World Forum for Harmonization of Vehicle Regulations**Working Party on Lighting and Light Signalling****Seventy-second session**

1958 Agreement - Regulations**Regulation No. 86 (Installation of lighting and
light-signalling devices for agricultural tractors)****Proposal for draft amendments to Regulation No. 86
(Installation of lighting and light-signalling devices for
agricultural tractors)****Submitted by the Chair of the Informal Working Group on
Agricultural Vehicles Lighting Installation (AVLI)***

The text reproduced below was prepared by AVLI to update and revise Regulation No. 86. It is based on document E/ECE/324/Rev.1/Add.85/Rev.1 and supersedes the original proposal in ECE/TRANS/WP.29/GRE/2014/2. The modifications to the current text of the Regulation are marked in bold for new or strikethrough for deleted characters.

Direction-indicator lamps - Geometric visibility

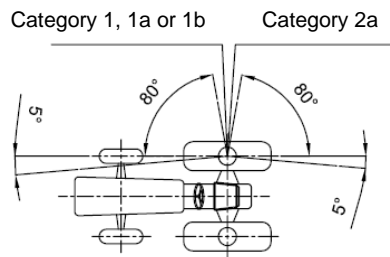
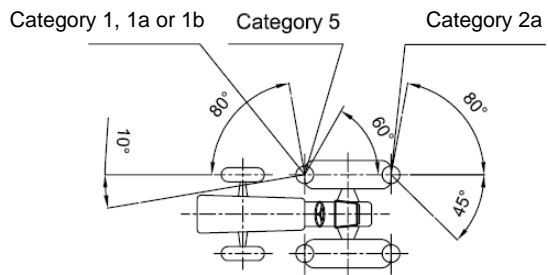
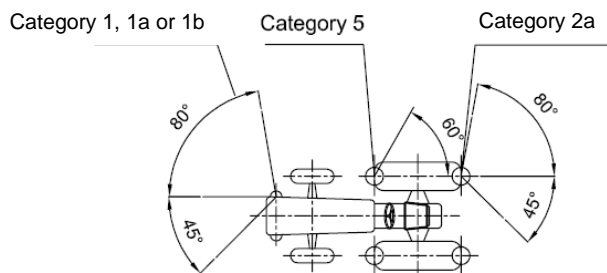
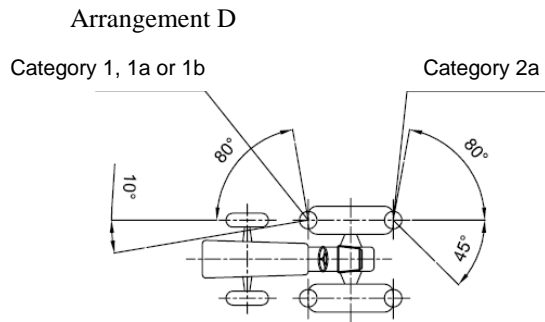
(see paragraph 6.5.54.)
